**LEBANON PLANNING BOARD
MARCH 29, 2021 - 6:30 PM
REMOTE VIA MICROSOFT TEAMS
LEBANONNH.GOV/LIVE**

**Basic Holdings, LLC,
5 & 11 Oak Ridge Road,
(Tax Map 4, Lots 5 & 6),
zoned R-3
PB2020-31-FMAJ**

Staff Memorandum – PB2020-31-FMAJ – *continued from 3/8/21*

Final Major Subdivision Review, Site Plan Review, and Conditional Use Permit for 22-unit Planned Unit Residential Development (PURD)

Drainage

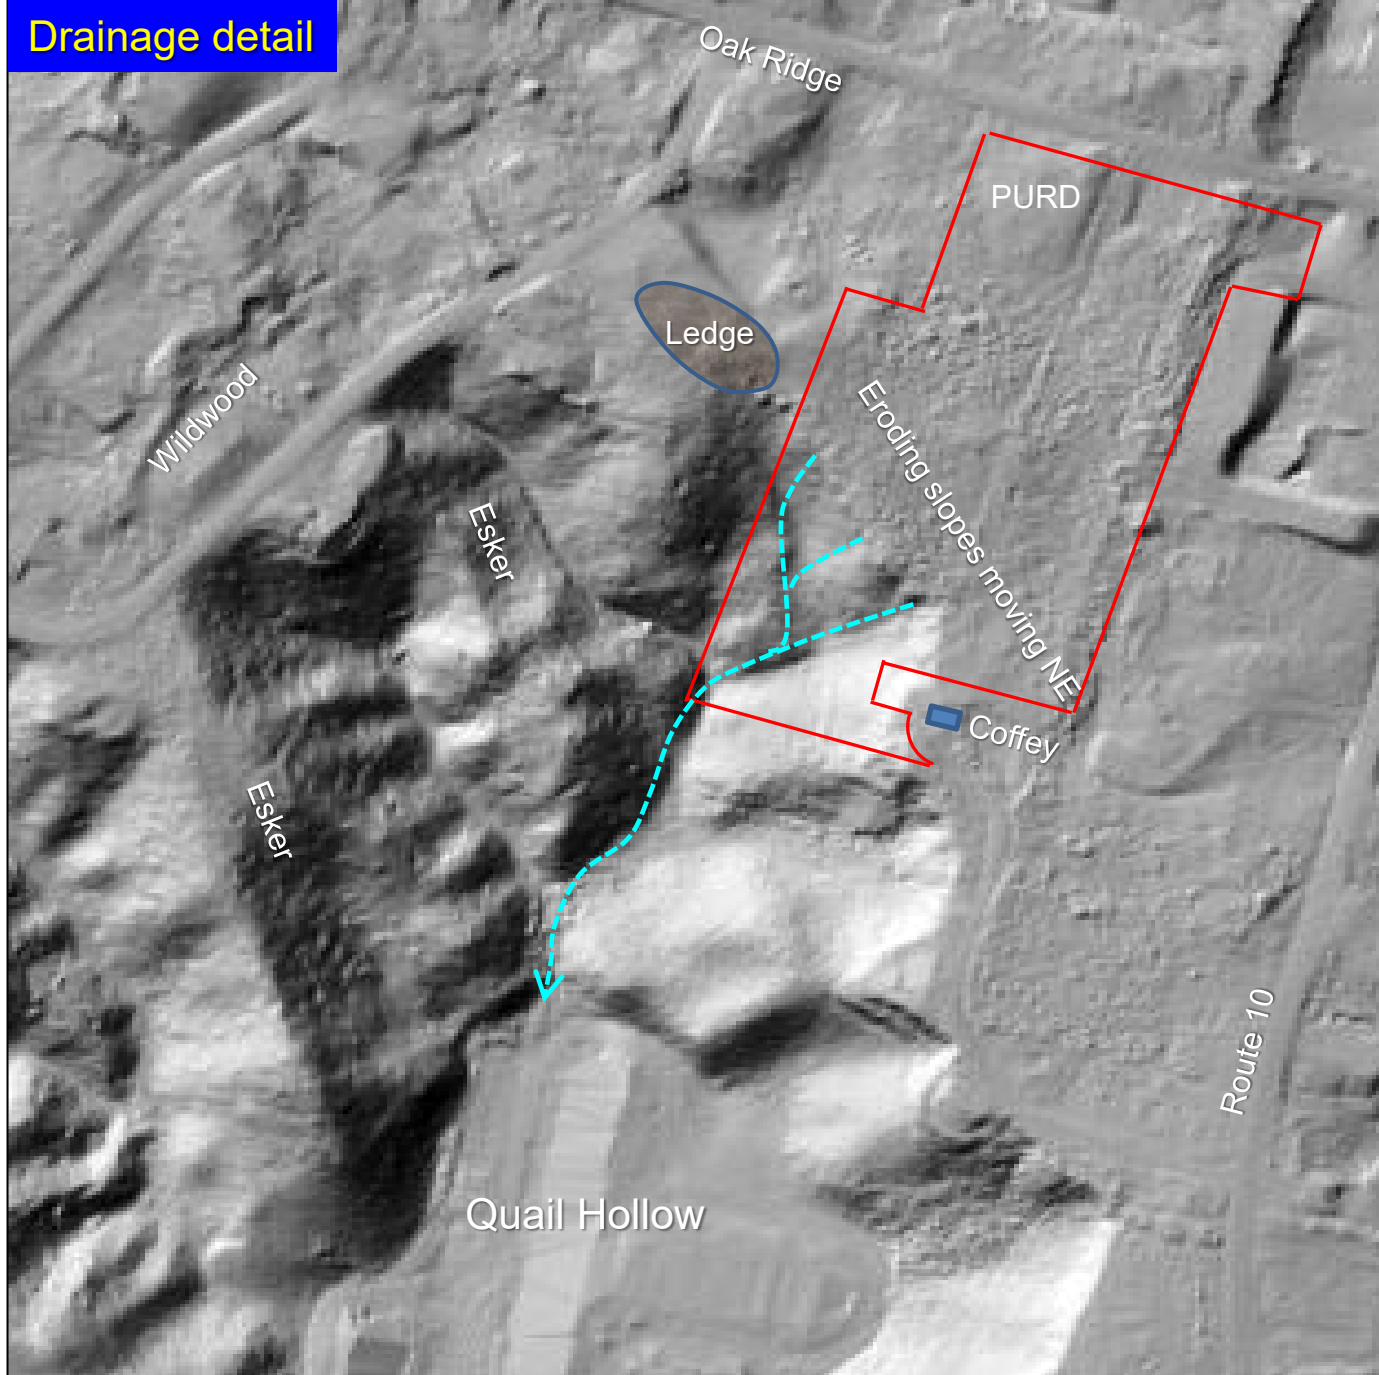
Turquoise lines show drainage routes from PURD; elev. drop = 90 ft.

Significant surface runoff, groundwater, and snow melt from newly planned snow storage likely to divert south to Quail Hollow

What happened to the “Rain gardens” and “Forebays” in the original plan?

Ravine end at Quail Hollow is saturated

Erosion at southern end

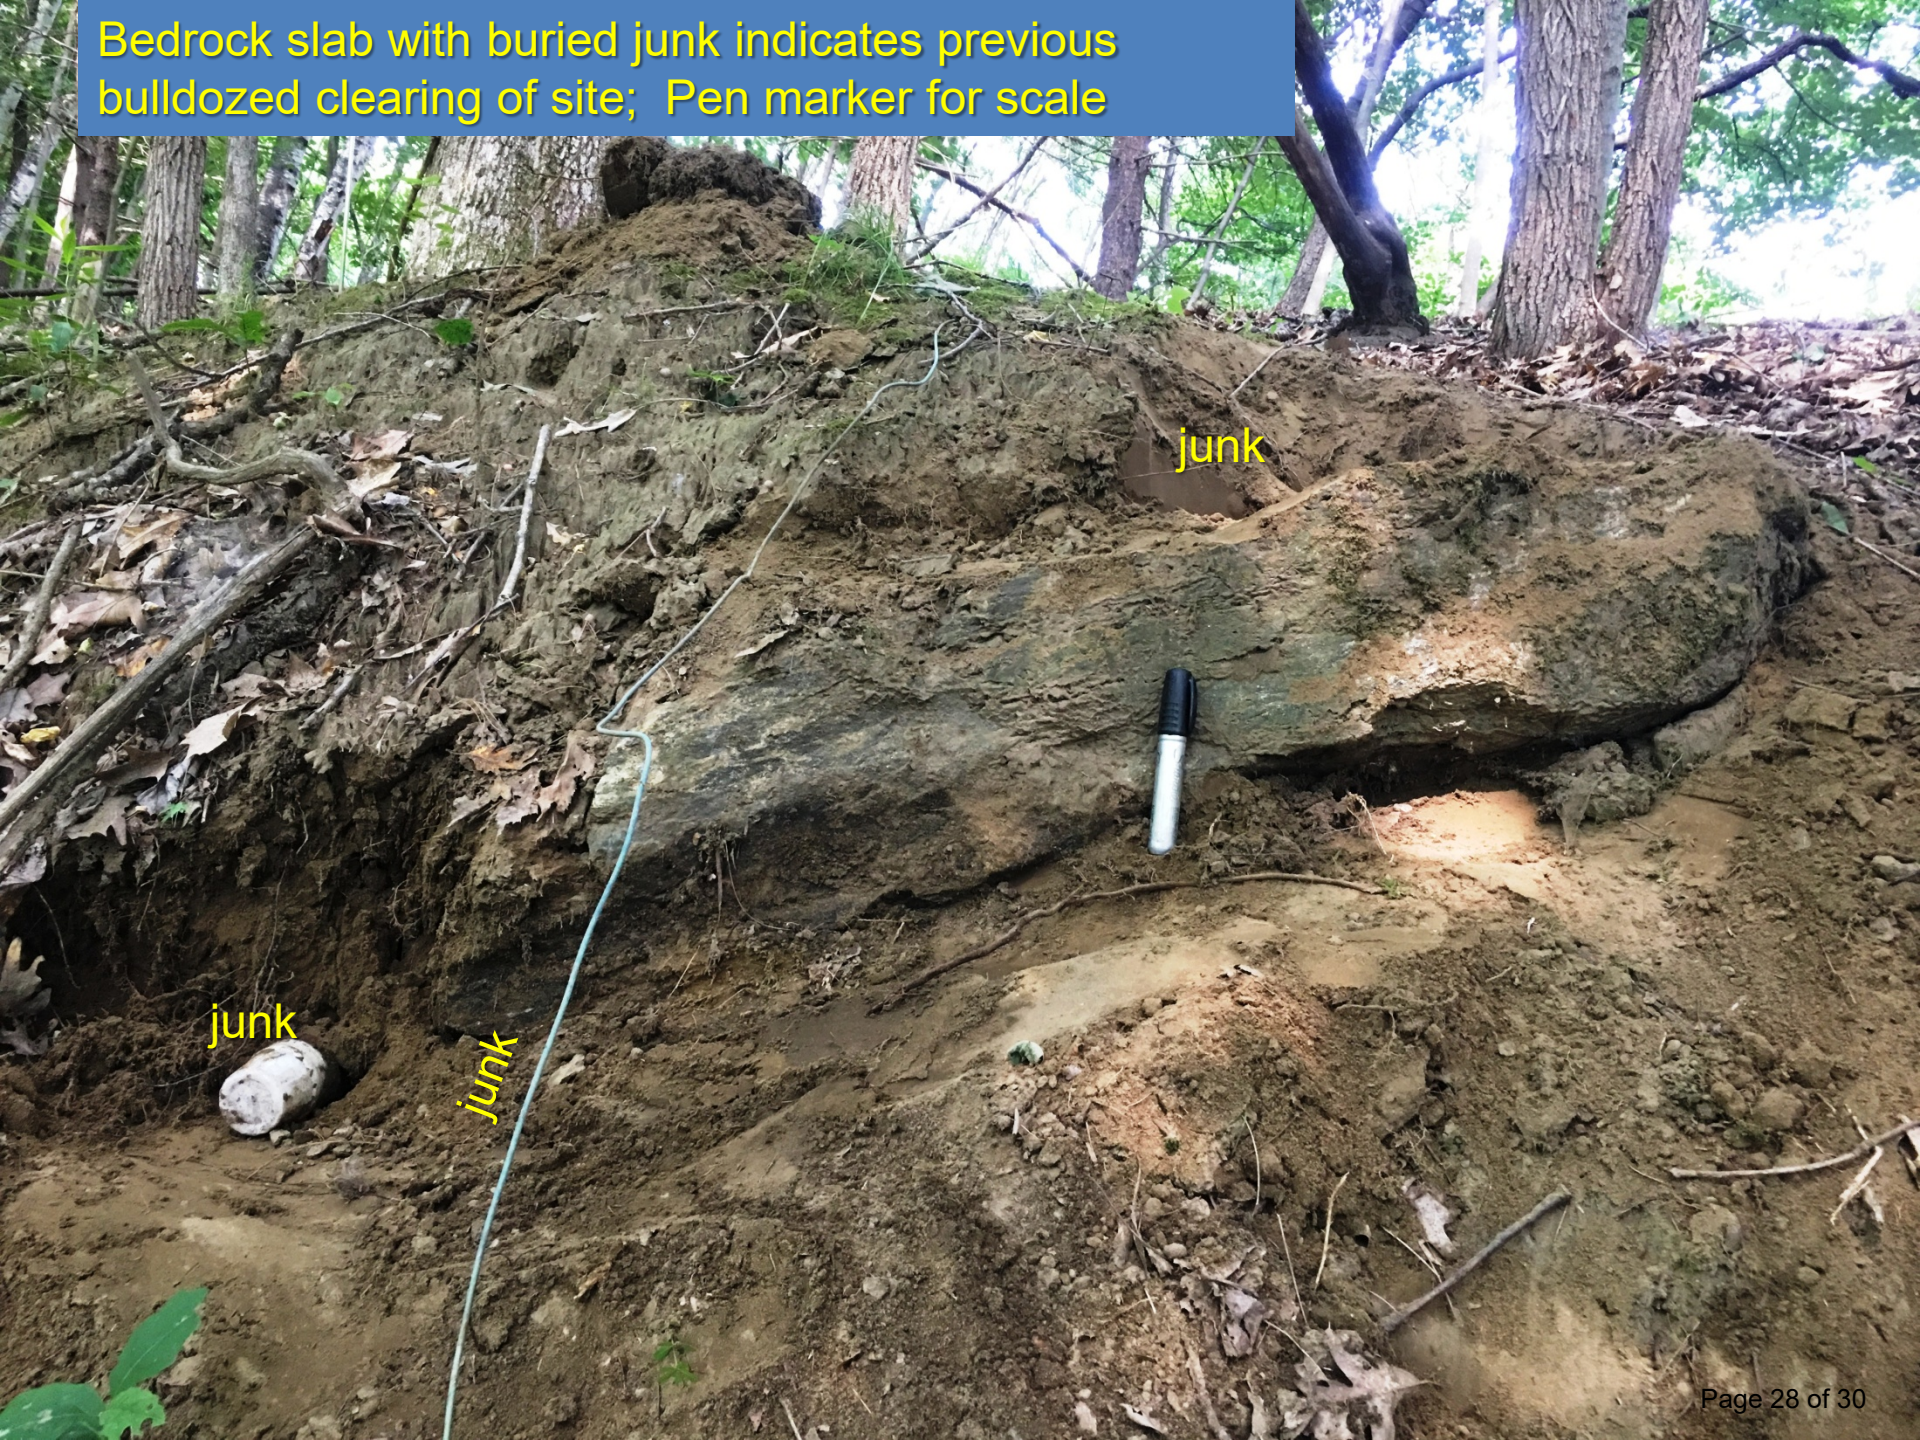
Poorly vegetated
and unstable

Half-buried debris
indicates active erosion

Partly buried junk means active soil transport, erosion, and suggests *contamination*. Photos show 30-40% of what is present.

Half-buried junk, partly exposed or covered by *erosion*.

Bedrock slab with buried junk indicates previous bulldozed clearing of site; Pen marker for scale

Contamination

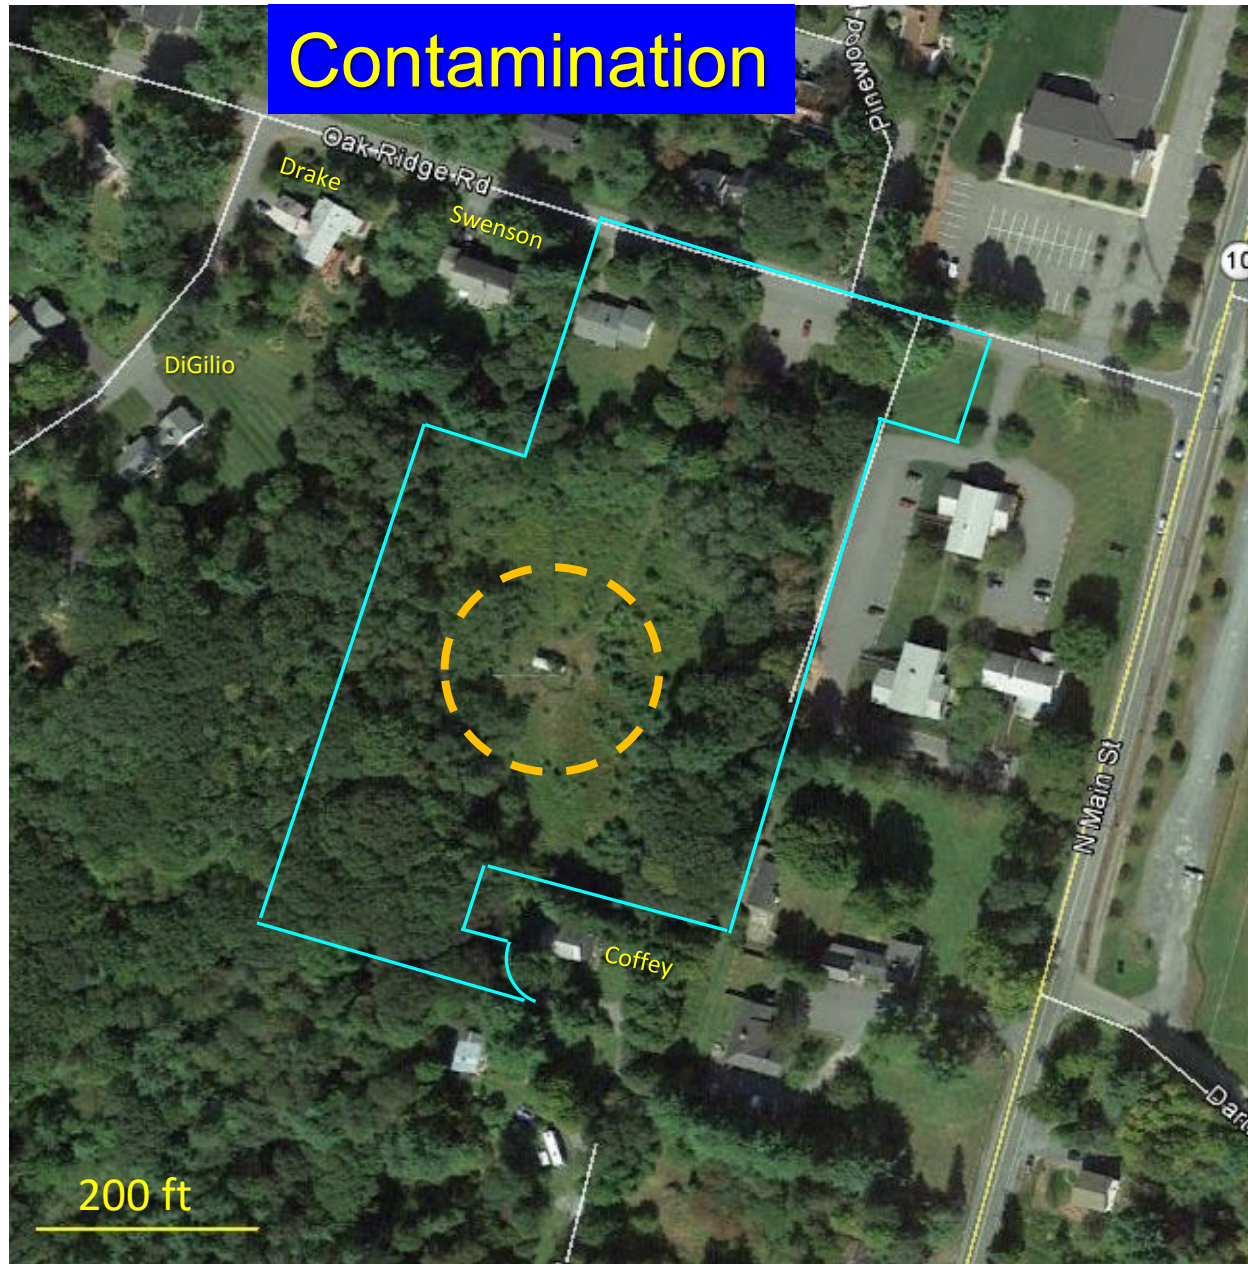
DiGilio, Drake and Rand septic tanks drain to PURD; Coffey residence is on edge of ravine and her septic system is *below* the edge.

Antenna, 200-foot diameter copper mesh, and 1948–1949 construction debris, including unused mesh and oil and gas spillage, likely contaminated deeper soil. When mobilized contamination will likely drain toward Quail Hollow.
